POWER PLANT - ENGINE - INCORPORATE REVISED BOLT LENGTH AT CP5675 - CATEGORY CODE 6 -
MOD.ENG-71-0062

V2500-ENG-71-0062

Installation of the Bolt at CP5675 Before and After alteration
Fig.1

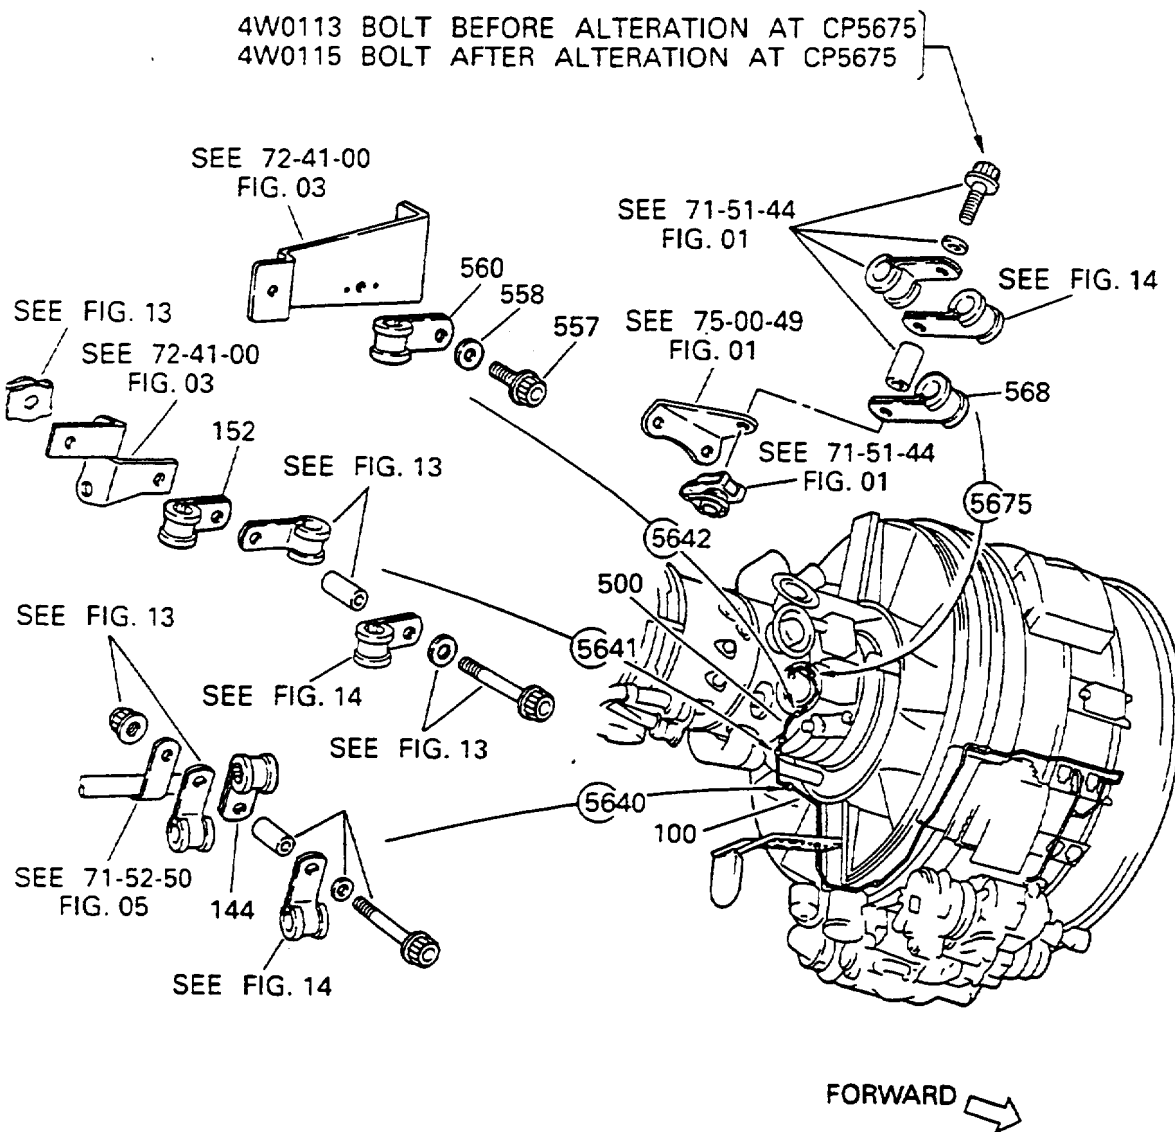
Difficulty in assembly may occur when installing the bolt at clipping point CP5675 because of insufficient length of the bolt.

- (a) At clipping point CP5675, the existing 4W0113, Bolt, has been changed to new 4W0115, Bolt, to increase the length of the bolt. (see Figure 1.)

- (1) At CP5675, install new 4W0115, Bolt, by the approved procedures in the Engine Manual, 72-00-40, Installation. (Refer to Figure 1, and 1.K. (2).)
